**PARTS & SERVICE  
NEWS**

REF NO.	<b>AT03143</b>
DATE	<b>Aug. 7, 2003</b>
<b>(C) Page 1 of 4</b>

**SUBJECT:** INTRODUCTION OF IMPROVED BODY POTENTIOMETER LINKAGE FOR HD465/605-7

**PURPOSE:** To introduce improved body potentiometer linkage for use on HD465-7 and HD605-7 dump trucks

### 3. Details of the modification

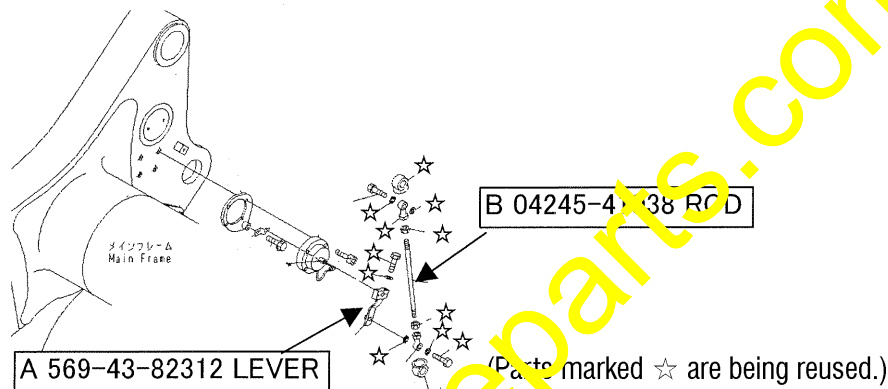
- The lever and the rod being installed to the body potentiometer have been modified so that the linkage may not exceed the upper dead point even when the aforementioned dispersions of the parts dimensions exist.

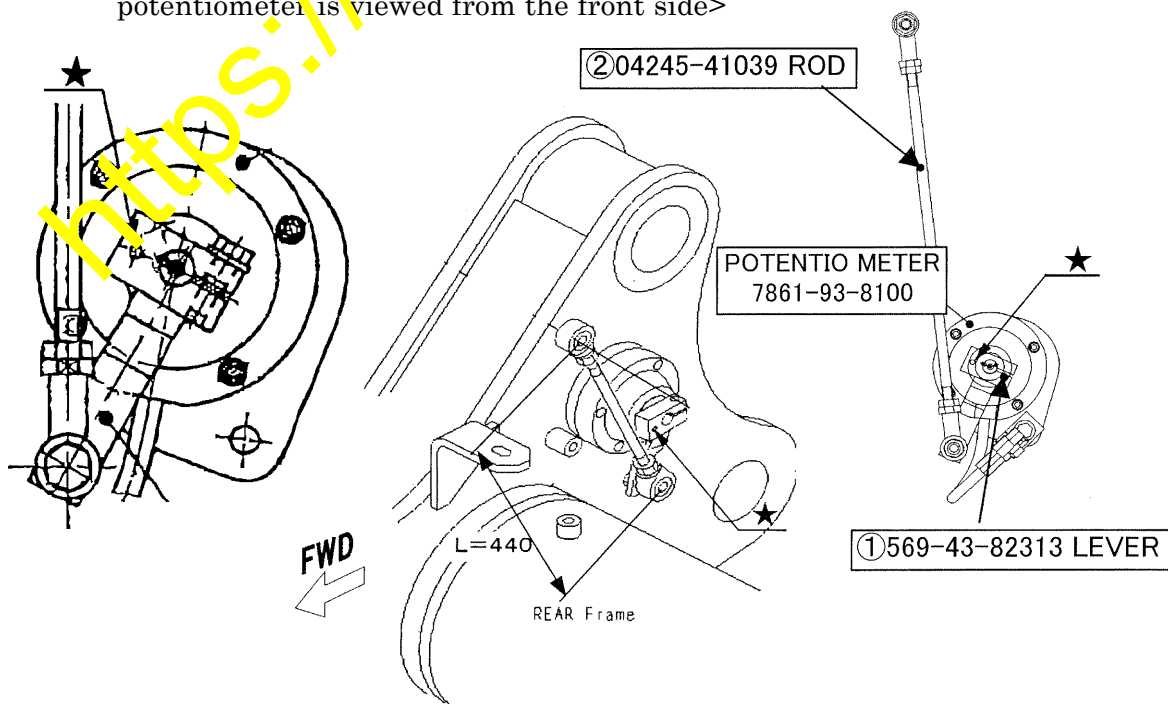
- (1) Remove the lever A (569-43-82312) and rod B(04245-41038) from the vehicle.  
(Those bolt, washer, rod end, etc. which have been removed as above are being re-used.)

- (2) Install the lever ① (569-43-82313) and a rod ② (04245-41039) to the body potentiometer. (Do not fasten the body side at this time.)
- (3) Matching the hole in the lever ① and the hole (☆ marked section) in the potentiometer (7861-93-8100), insert the positioning pin to fasten the lever ①.  
(A  $\phi 5$  positioning hole is being opened in the lever ① and in the potentiometer, respectively.)

<★ The hole directed to the lower left when the potentiometer is viewed from the front side>

### 3-3 Adjustment

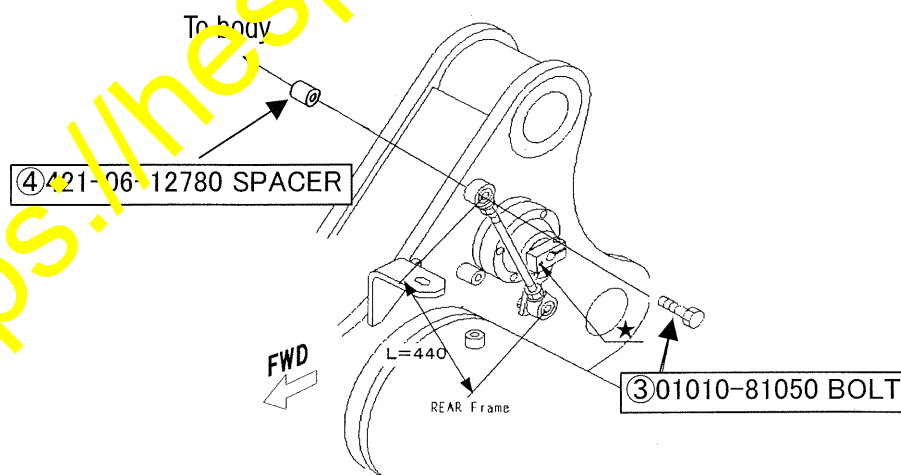
- (6) If the value of the "BODY POSITION" is out of the above standard value, pull out the positioning pin and adjust the angle of the lever ① to set the value of the "BODY POSITION" within the standard value.

- The value will increase when the lever is turned clockwise and the value will decrease when the lever is turned counter-clockwise.
- (7) When the value of the "BODY POSITION" is confirmed to be within the standard value, at that position, fasten the rod to the body using the bolt ③ (01010-81050). At that time install the spacer ④ (421-06-12780) between the boss on the body and the rod end.  
Rod end standard length: 440 mm

- In case the rod length is 436 mm or less, remove the rod once and change the angle of the lever ① and make the adjustment once again in the low end side of the standard value of the "BODY POSITION".
